ENTSO-E responses to VGB important items from 03.03.2018 GC ESC

GC ESC, 12 June 2018, Ljubljana

Art.18.2.a : additional reactive power

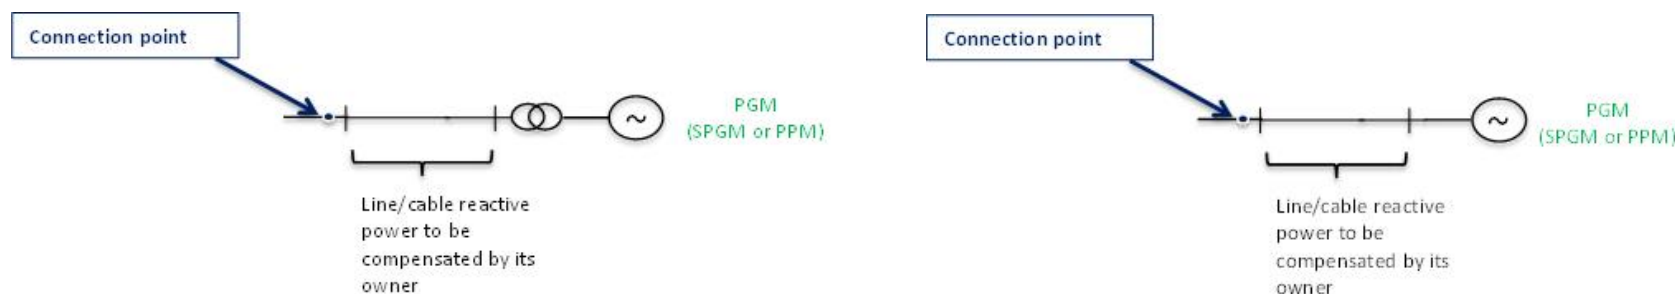
- Additional reactive power (Art.18.2.a) is not clear. Requirements apply at the connection point. Why this provision? See also Art. 18.2.b.iii.

- It is correct, that the reactive power capability shall apply at the grid connection point.
- with regard to reactive power capability: the relevant system operator may specify reactive power to be compensated if the power generating module is connected by a line or cable to the connection point. This line or cable can either connect the high-voltage terminals of the step-up transformer of the power generating module with the connection point, or the alternator (or converter) terminals with the connection point, if no step-up transformer exists. This reactive power shall compensate the reactive power demand or production of the line or cable and shall be provided by the responsible owner of that line or cable.
